U.S. EPR Cyber Security

October 6 2009 DCWG Meeting with NRC

October 6, 2009 NRC Presentation

Figure 1: U.S. EPR I&C Conceptual Diagram - Cyber Security Levels (DRAFT-PRELIMINARY)

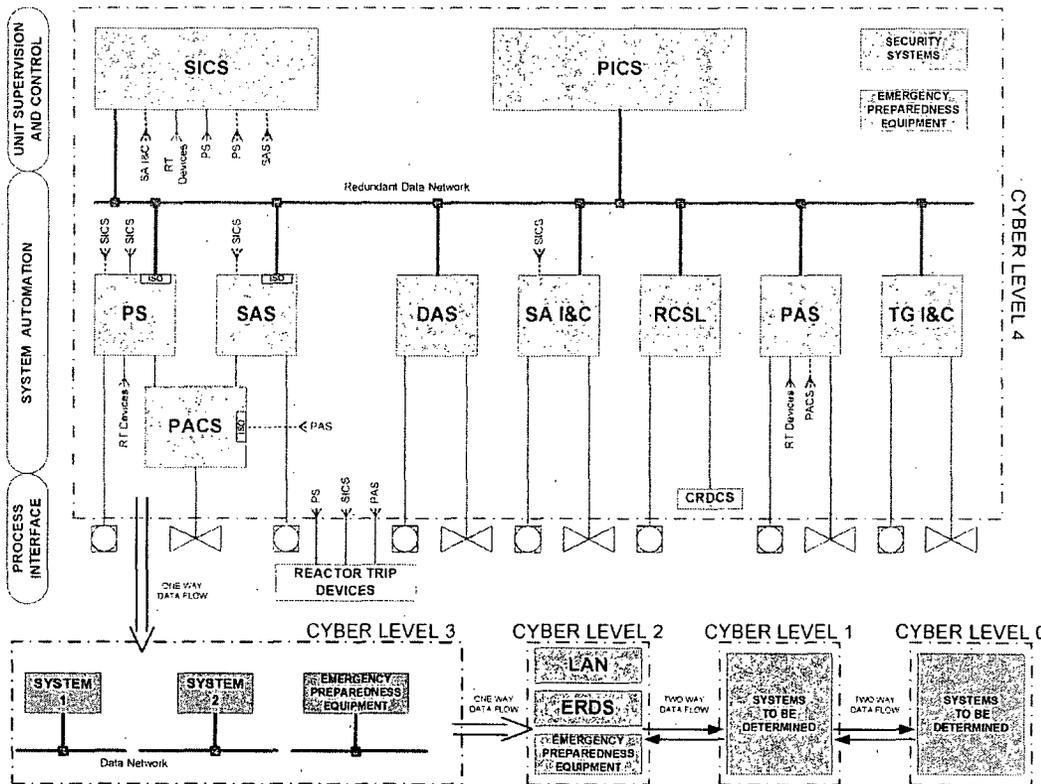
- *“Ensure that any non-safety equipment (including the supporting networks) communicating to safety systems (or EP, security, and support systems) is also afforded level 4 protection”*

- Regulatory Guide 5.71. Section c.3.2.1- Security Defensive Architecture, is silent on the classification level for Emergency Planning:
 - “CDAs associated with safety, important to safety and security functions, as well as support systems and equipment which, if compromised, would adversely impact safety, important to safety and security functions, are allocated to Level 4 and are protected from all lower levels”*

- Some of the equipment supporting emergency preparedness functions--such as offsite communications equipment necessary to maintain two way communications with outside organizations such as Federal, State and Local authorities—must be able to communicate with lower cyber security level equipment maintained by those outside groups

- The U.S. EPR non-safety systems within the scope of 10 CFR 73.54 are afforded level 4 protection
 - Only identified exception is Emergency Planning Due to Design Necessities

- Such data flow with outside organizations dictates that some of the equipment be placed in cyber security level 0-2
 - Remaining EP equipment will be placed in cyber security levels 3-4
